# INNER WEST COUNCIL

## DEVELOPMENT ASSESSMENT REPORT

| <b>Address</b>                                    | 223 Trafalgar Street, Stanmore   |
| <b>Proposal</b>                                   | To demolish part of the premises and carry out ground and first floor alterations and additions to a building and to use the premises as a transitional group home for a drug and alcohol rehabilitation facility. |

1 Proposed Roof Plan  
Scale: 1:100

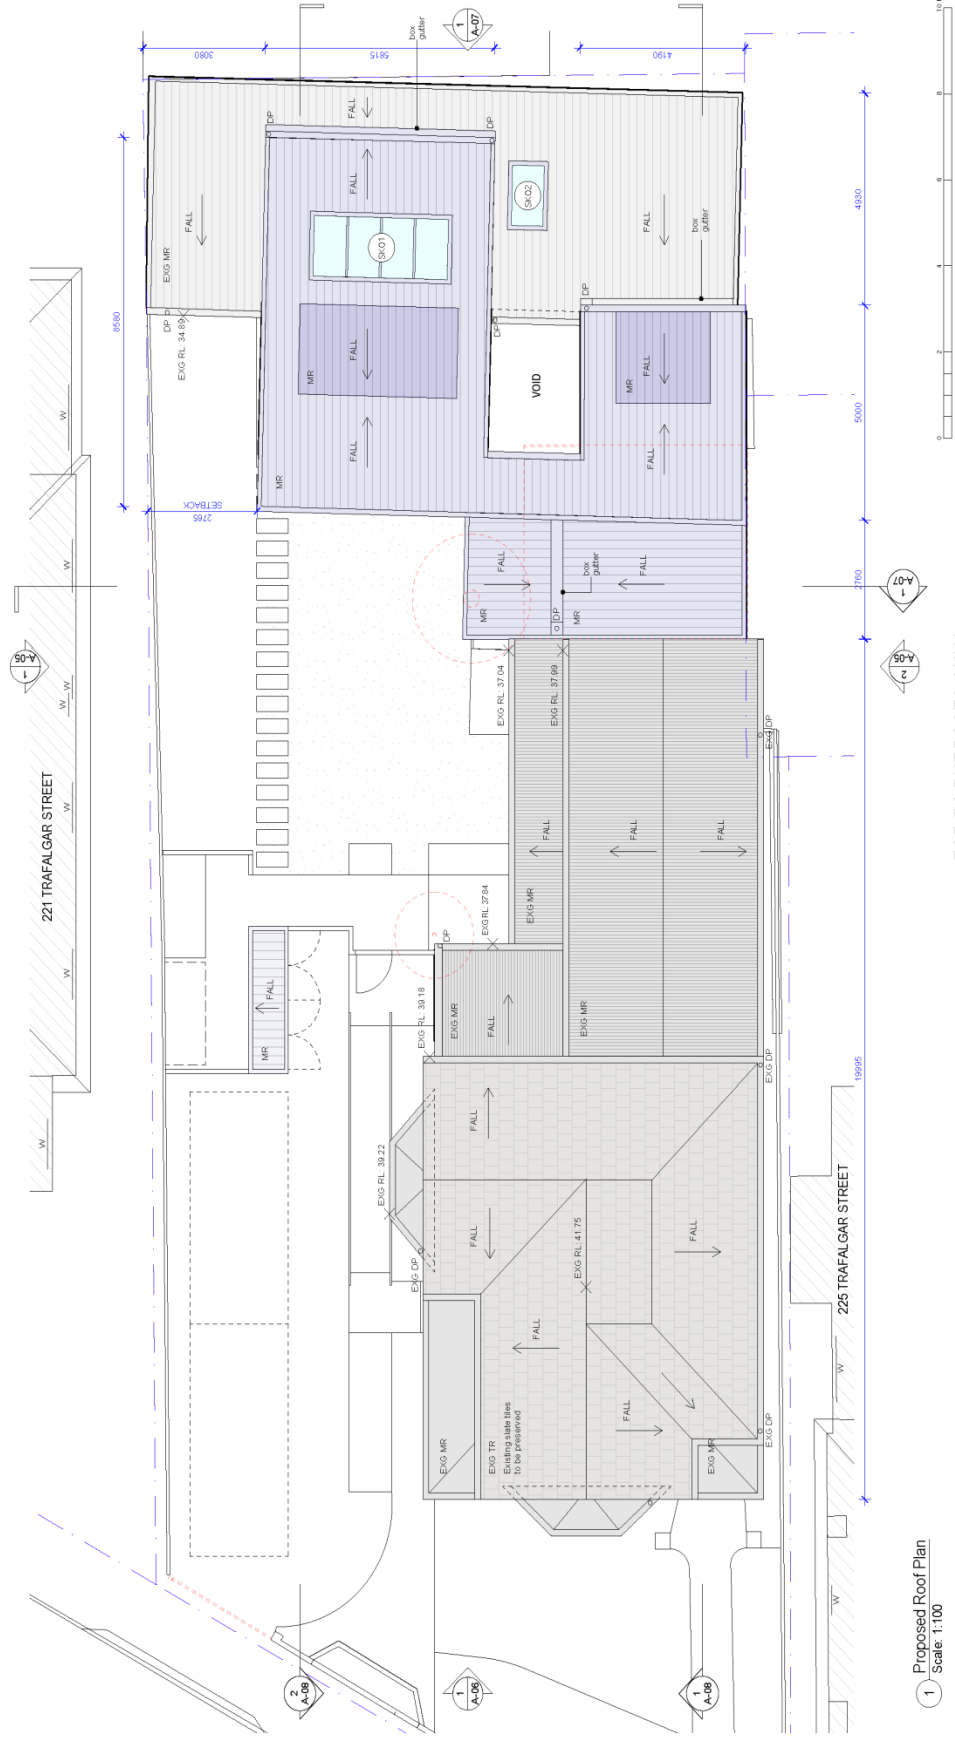
- 4. Notes should be included in the roof plan (drawing A-04) that the existing slate tiles to the primary roof (cross-gable) are to be preserved.*
- 5. Please replace the notes 'Retain and restore existing timber staircase. Any alterations to comply with BCA requirements. To be approved by council's heritage office' with 'alterations and/or additions to the original stairwell and timber railing to comply with BCA are not permitted. Alternative solution for fire egress is to be achieved'.*

1 Primary Building - East Elevation  
Scale: 1:100

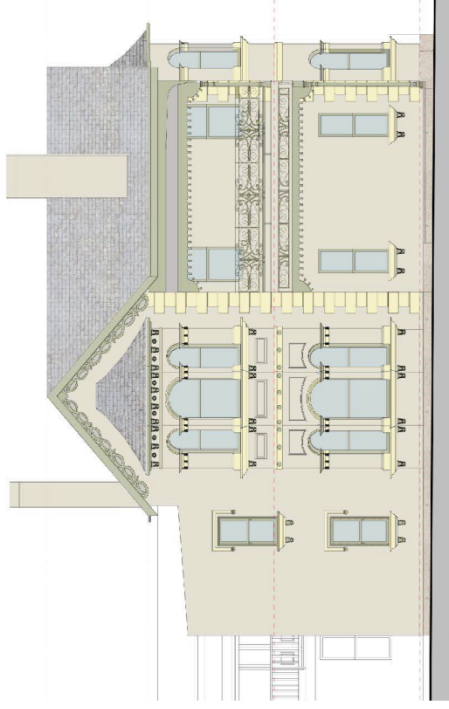
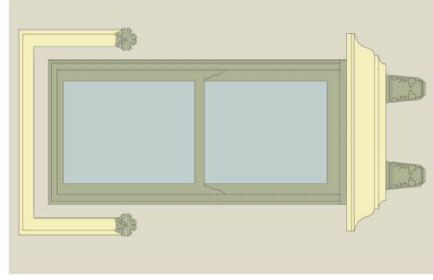
- d) *New painting will be required to the side wall of the primary building (East Elevation) as a result of the construction of a new window at Ground Level. The detailed colour scheme of the wall, window, sill and moulding is to be included in the conservation works sheet or schedule of finishes.*
